## SWIVEL BRACKET BUSHING GREASE PATH

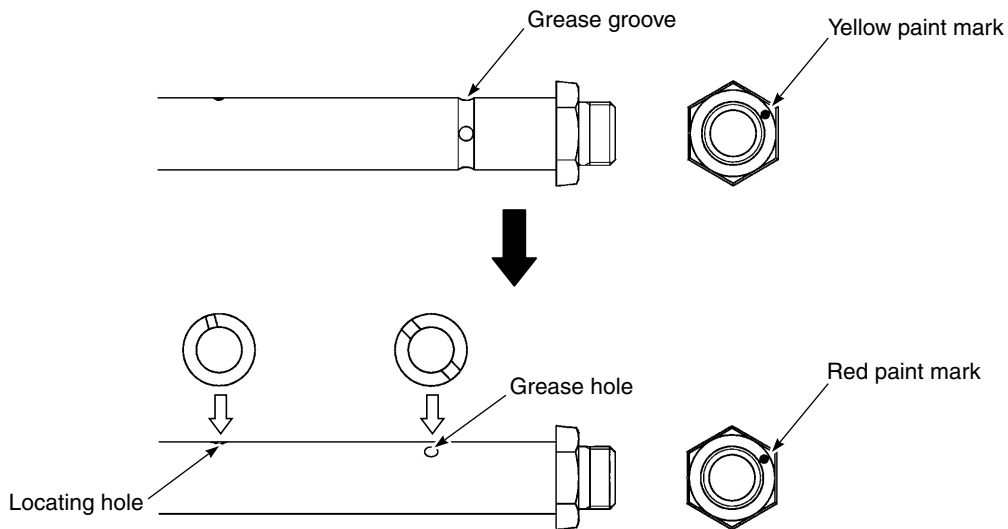
The lubrication path for the swivel bracket bushing has been redesigned affecting the swivel bracket, bushing and shaft. Basically, the grease routing slot located on the clamp bracket shaft has been moved to the clamp bracket bushing.

The swivel brackets have been redesigned from two to only one grease nipple on the port side.

The clamp bracket shaft has been redesigned with a clearance hole in place of a slot for routing the grease lubrication.

Install the clamp bracket shaft with "Red" paint marking toward up side.
